COUNCIL ACTION FORM

SUBJECT: REVISIONS TO THE APPROVED PRELIMINARY PLAT AND MASTER PLAN FOR NORTHRIDGE HEIGHTS SUBDIVISION

ATTACHMENT C

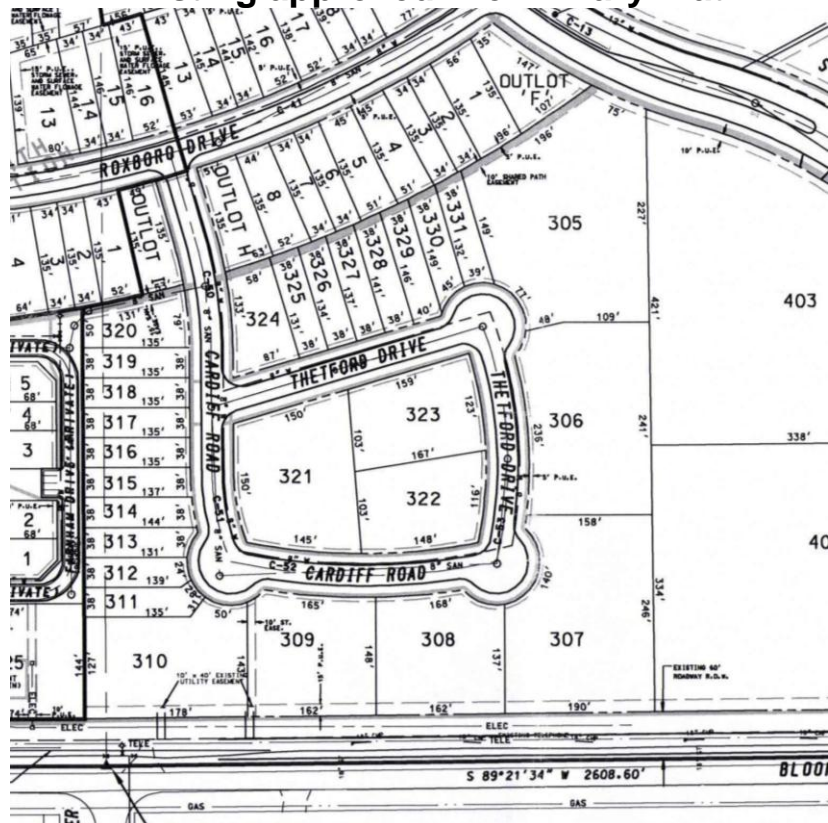
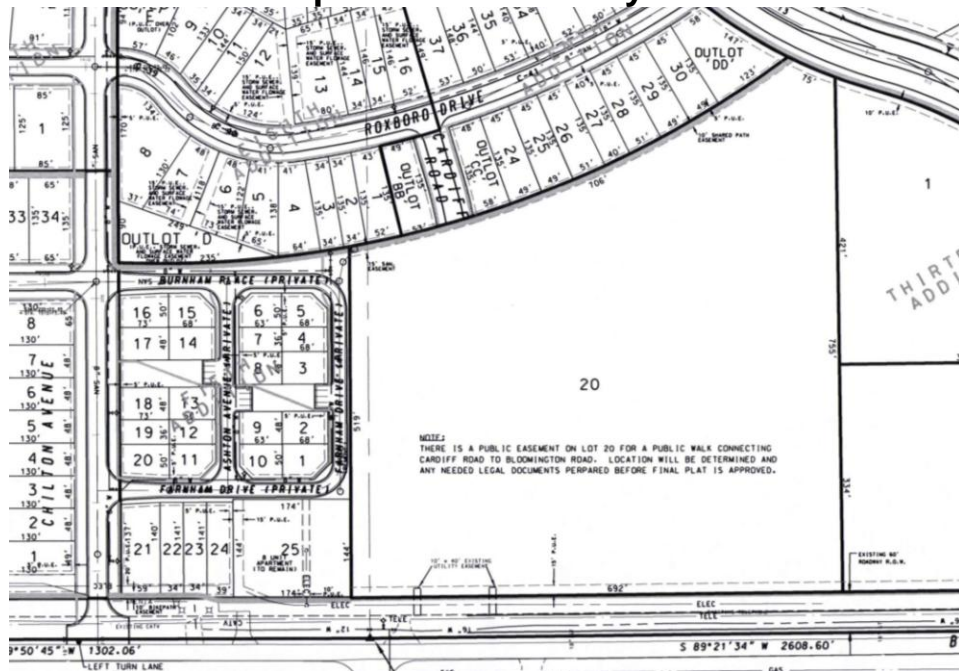
- On Sheets 7 and 11, combining Lots 305 through 331, and eliminating the proposed public streets (Cardiff Road extension, and Thetford Drive) to create the single Lot 20. The existing public street called Cardiff will provide access to the lot. (See Attachments B and C)
- On Sheet 3 General Note 6 has been revised **from** "Access to individual lots from Stange Road will not be permitted, except at the locations shown on the Preliminary Plat" **to** "Access to individual lots from Stange Road shall be approved by City of Ames Traffic Engineer." (See Attachment D)
